From: [REDACTED]
Subject: FW: 16/02193/FUL Proposed car park Connaught Court Fulford York

Re: 16/02193/FUL Proposed car park Connaught Court Fulford York

Re: Street record Fulford Park York: construction of car park

Ref: 16/02193/FUL

**ITALO 1****MAIN CHARACTERISTICS**

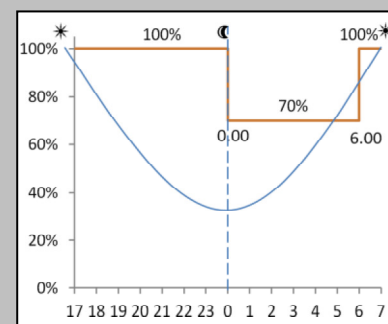
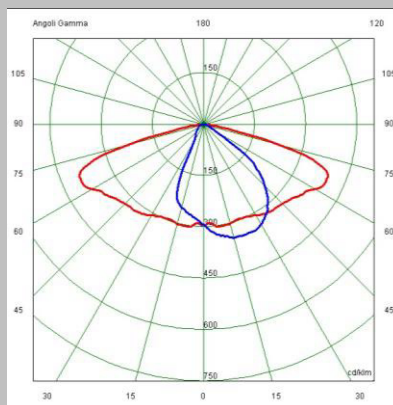
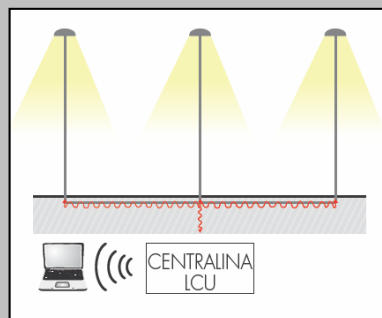
Please could you request more information on the specification of this, including a plan showing the light spill and details of measures taken to reduce light spill?

On the proposed site plan there are two lighting columns at the new car park, labelled 'standard light to match existing'. Please could you request more information on the specification of this, including a plan showing the light spill and details of measures taken to reduce light spill?

The lighting standards will be designed to minimise light 'spill'. We attach a copy of the data sheet for the Kingfisher Italo 1 street light unit which would meet these requirements.
